## CERTIFICATE OF APPROPRIATENESS

**Property:** 642 Columbia Street, Lot 23, Block 281, Houston Heights Subdivision. The property includes a noncontributing 2,086 square foot, one-story wood frame brick clad single family residence and one-story detached garage situated on a 6,600 square foot (50' x 132') interior lot.

**Proposal:** New Construction – (Revision) Alter the fenestration design from a decorative divided 9-over-1 configuration to a divided 3-over-1 configuration. The proposed residence will also be shifted 5" to the south. Additionally, the window trim will be altered to be more decorative and the decorative porch posts will be simplified.

## WEST ELEVATION – FRONT FACING COLUMBIA STREET

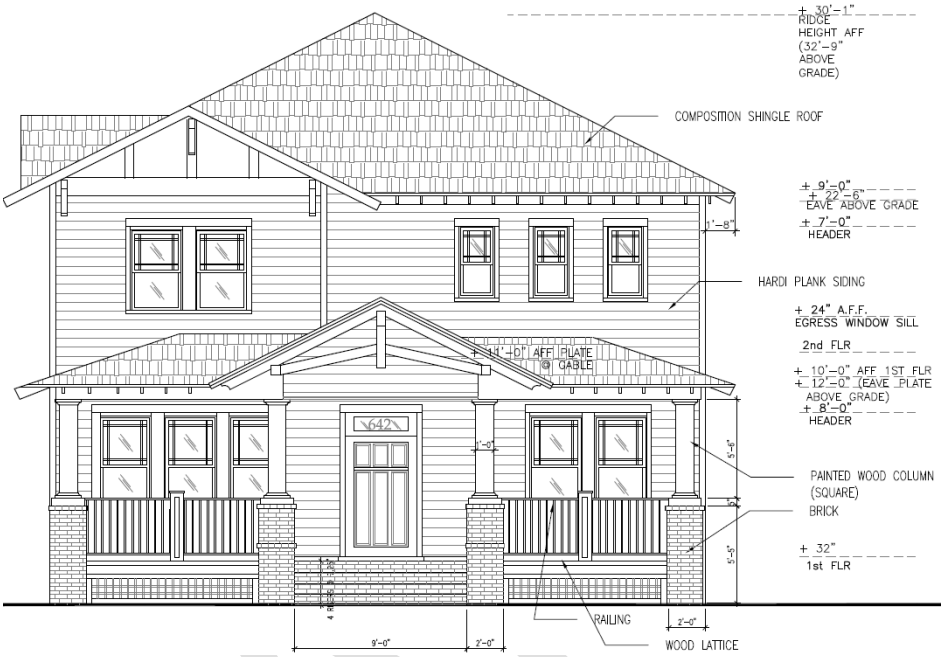
02-26-2015: The front elevation of the revised proposal will not be altered. See drawings for more detail.

## SOUTH SIDE ELEVATION

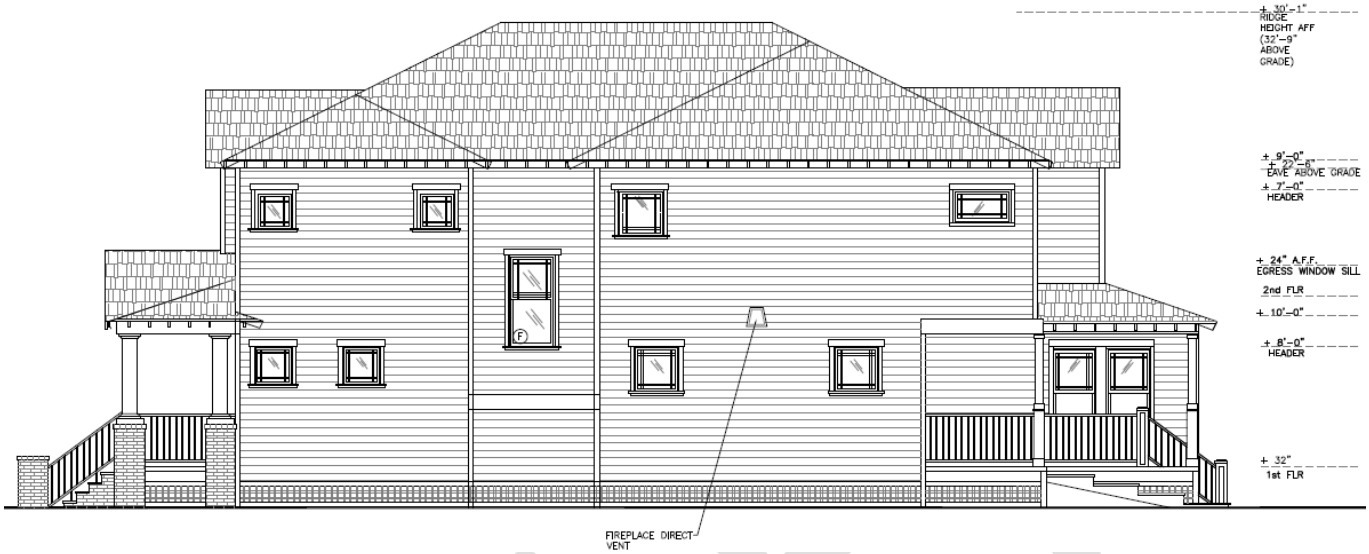
02-26-2015: The south elevation of the revised proposal will include two square fixed windows on the second story. To the east, an inset portion will include a single double hung window. The eastern portion will project out and include two square fixed windows on the first story and two fixed windows on the second story. A rear porch includes an additional pair of double hung windows. See drawings for more detail.

## WEST (REAR) ELEVATION

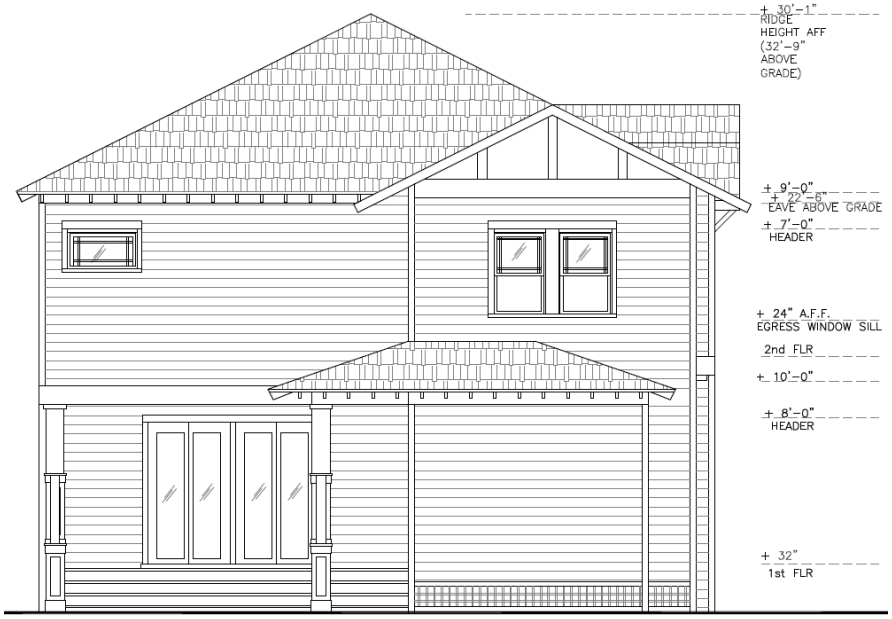
02-26-2015: The proposed revisions to the rear elevation of the residence will not visible from the public Right-of-Way. See drawings for more detail.

## SITE PLAN

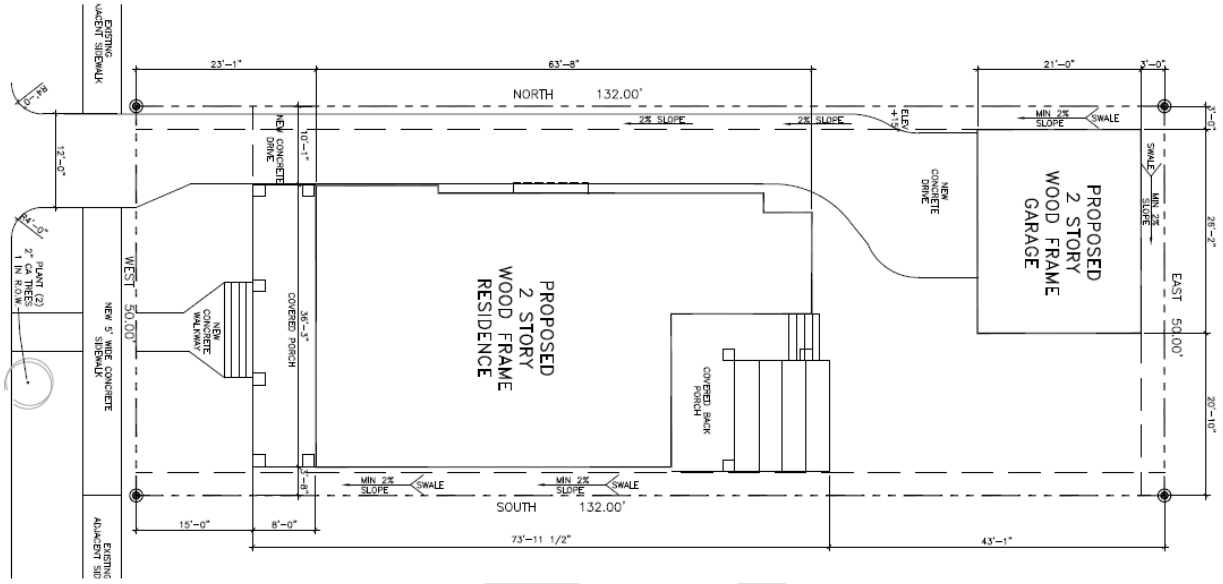
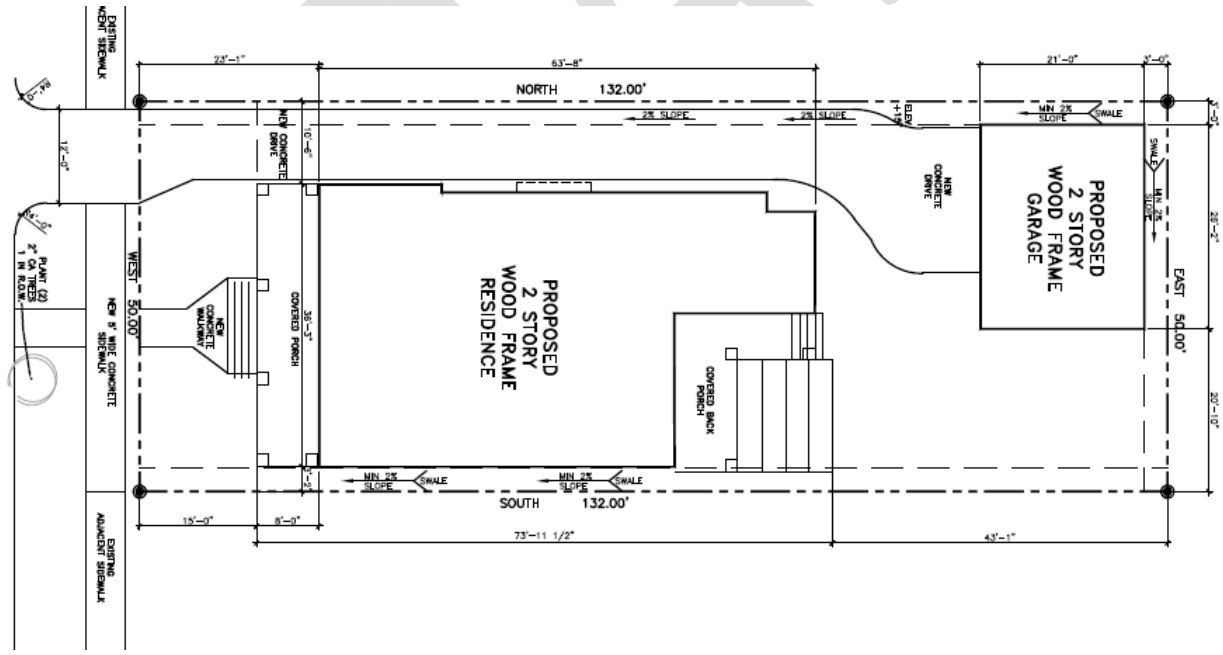
02-26-2015: In the revised proposal, the proposed residence will be shifted 5" to the south. The revised proposal will have a north setback 10'-6" and a south setback of 3'-2". See drawings for more detail.

## ROOF PLAN

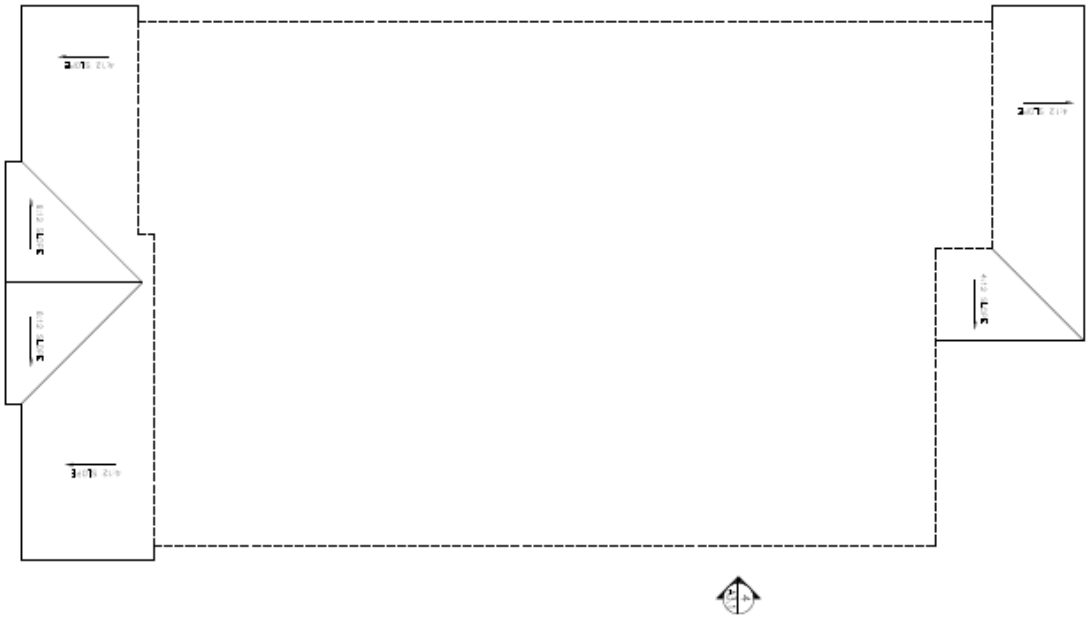
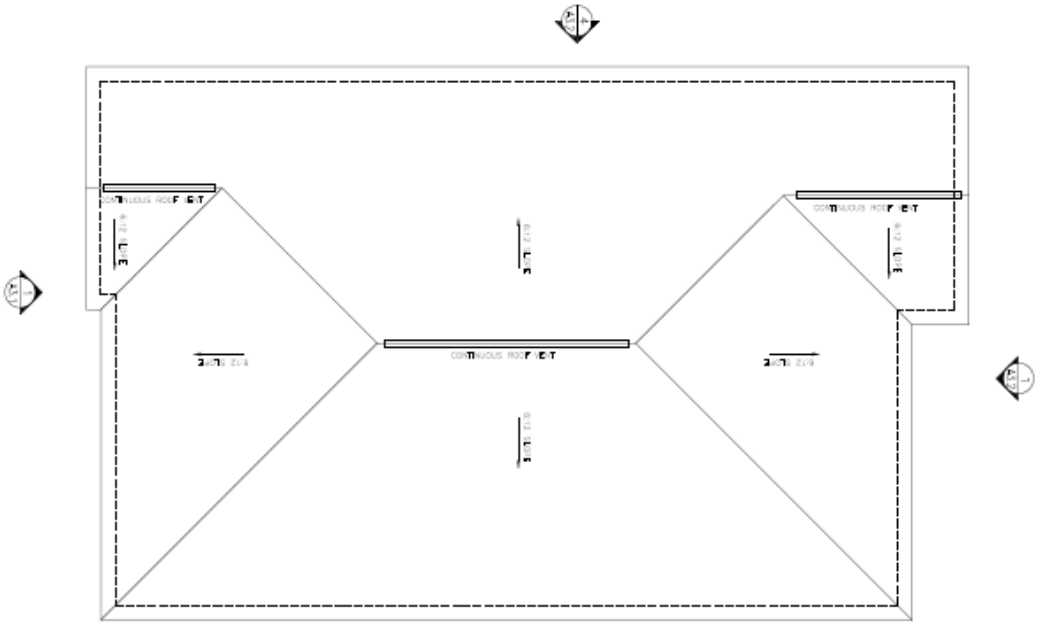
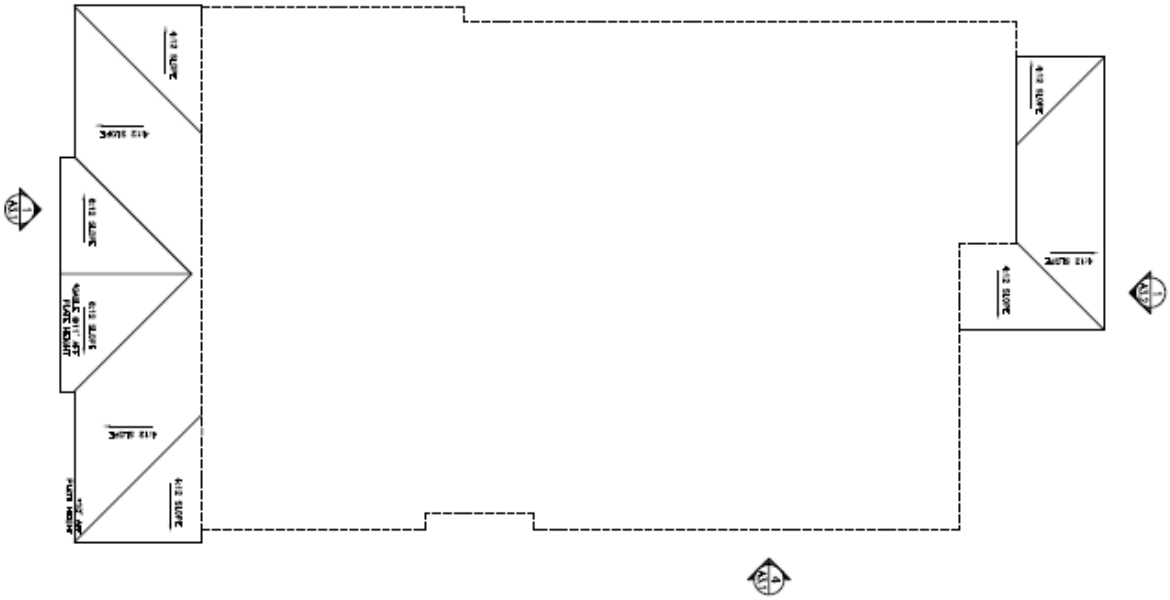
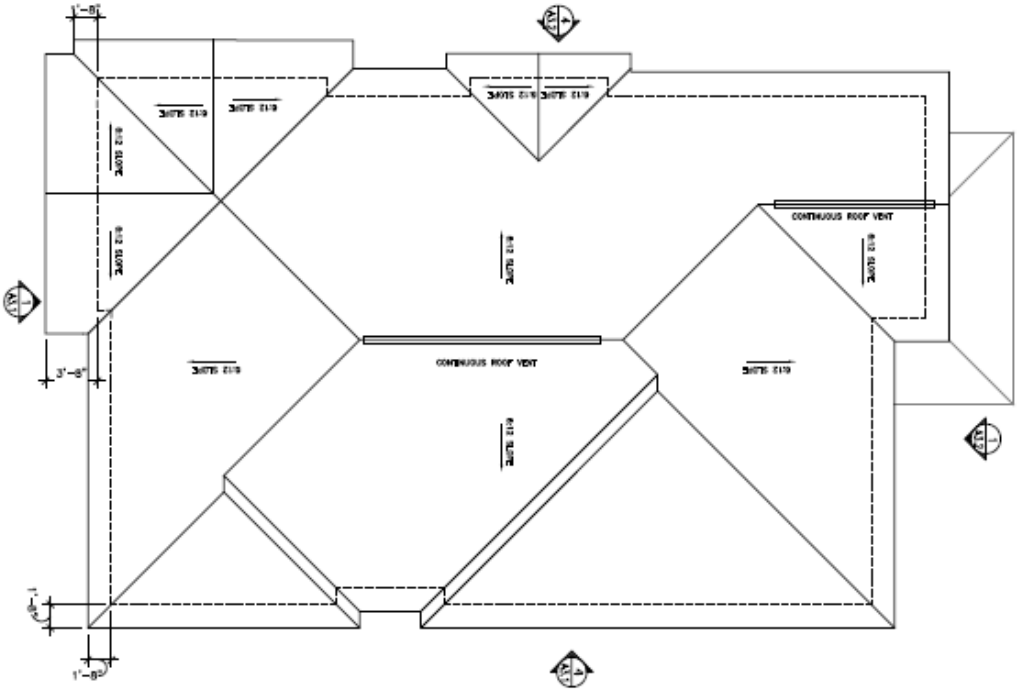
02-26-2015: The roof of the revised proposal will not be altered. See drawings for more detail.
